# **SERVICE BULLETIN**

Subject: Fuel Nozzle Sheath Inside Depth Too Shallow

Revision: Original Service Bulletin No: 141125-001

Figure 1, Section Views Showing Extra Material Location and Potential Contact Location with Sheath and Duplex Adapter

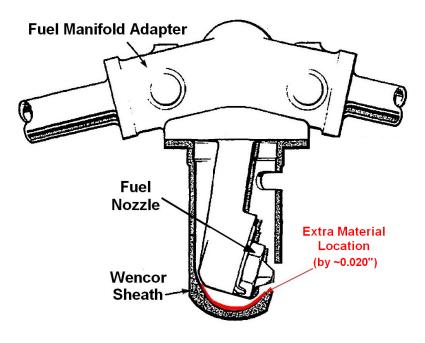
The inside depth of the Wencor Sheath was designed with approximately 0.020" extra material in the bottom of the inside area of the Sheath for improved manufacturability. The extra material created the possibility of contact with the Duplex Fuel Manifold Adapter or the bent tabs on the key washer or the hex on the fuel nozzle as shown in Figure 1.

A single Wencor customer reported a problem with the installation of the Wencor Sheath onto a Duplex Fuel Manifold Adapter. The investigation discovered that there would be direct contact between the inside dome area of the Sheath and the Duplex Fuel Manifold Adapter or the bent tabs on the key washer or the hex on the fuel nozzle due to extra material located on the inside dome area of the Sheath as shown in Figure 1.

Any Wencor Fuel Nozzle Sheath's that have not already been installed should undergo a trial fit check to determine if there is contact with the Duplex Fuel Manifold Adapter, key washer or fuel nozzle during installation. Installation onto a Simplex Fuel Manifold Adapter should be acceptable. Any Sheath's that result in contact should be returned to Wencor for an improved replacement Sheath. This action will ensure proper service life on both the Sheath and the Duplex Fuel Manifold Adapter.

Figure 2, Exploded View of Sheath Installation

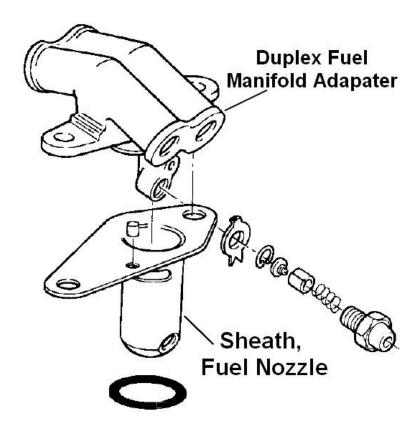
The Wencor Sheath, Fuel Nozzle is installed over both the Simplex and Duplex Fuel Manifold Adapters as shown in Figure 2. The Sheath serves primarily as a heat shield from the high temperature combustion gases as forced cooling air from the compressor section enters the slot near the Sheath flange and flows within the Sheath and out through the nozzle aperture hole. This cooling air also assists in fuel atomization on the PT6 series engines.
